Title: Cavalon Engine Mounting Bolts – Out Of Phase Check Torque		
AG-SB-2019-04-A-EN		Compliance Category: A - MANDATORY B – RECOMMENDED C – OPTIONAL
Applicability		
Aircraft type & model: Cavalon 915iS	Affected Serial number(s): All Cavalon fitted with a Rotax 915iS engine up to and including serial number V00464	
The maintenance manual to be referenced is this stated or subsequent issue.		As per AutoGyro website
This form is the response from AutoGyro GmbH either against a problem found in the product in service requiring a containment or rectification action, or as service information for aircraft modification incorporation. For help, contact AutoGyro on 49(0)5121 88056-00, or email airworthiness@auto-gyro.com.

(Pic.1)

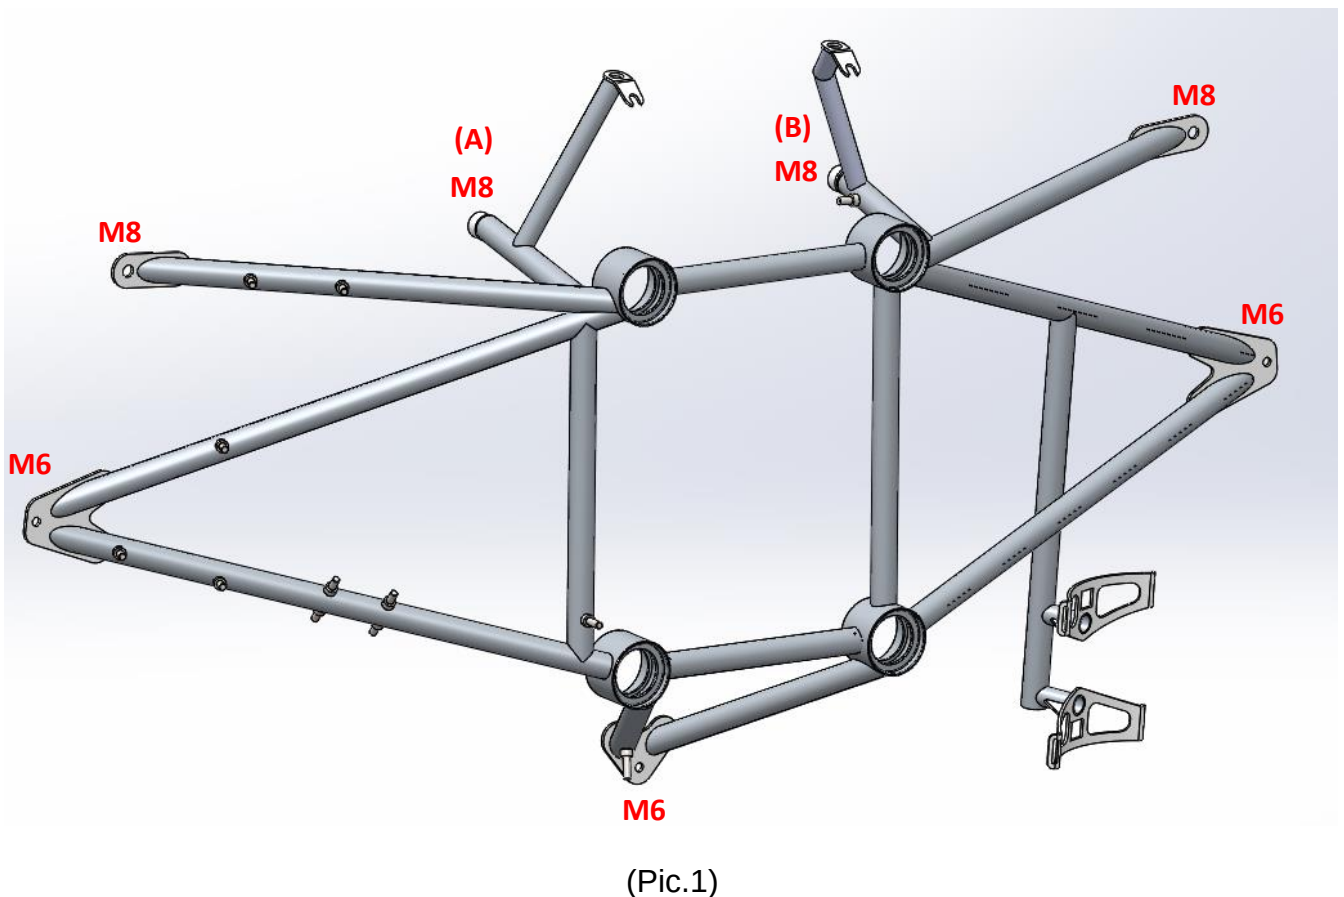
It has been found that the engine mounting frame (46764) on AutoGyro Cavalons fitted with Rotax 915iS engines may “settle” into the fire protection affixed to the engine bulkhead.

This can lead to some engine mounting bolts losing their correct torque.

This service bulletin introduces an additional, single, service inspection for a cheque torque on the engine mounting frame to bulkhead bolts **at 5 flying hrs, or within the next 5 flying hours**. Thereafter as called for in the 25 and 100 hr inspections in the service protocol “Engine and Services”, item 131.

1. Gain access to the engine mounting frame (46764) by removing the upper and lower engine cowlings in accordance with the AMM job card 52-00-00 4-1.
2. Carry out a check-torque of the 7 engine mounting bolts (pic. 1). All bolts are torqued to standard torques for the bolt size as stated in the AMM Part B 01-12-00:
 - M4: 2-3 Nm
 - M5: 5-6 Nm
 - M6: 11 +/-1 Nm
 - M8: 25 +/-3 Nm
 - M10: 35 Nm +/-4 Nm
3. Should the mounting bolts at positions (A) and (B) below be found to have lost torque, they should be individually removed, Loctite 243 applied, and re-fitted.
4. Should mounting bolts at any other position (secured by with Nyloc) be found to have lost torque, they should be tightened to the correct torques stated above in paragraph 2.
5. Re-fit the engine cowlings, ensuring the lower cowling M4 screws are re-fitted using Loctite 221.
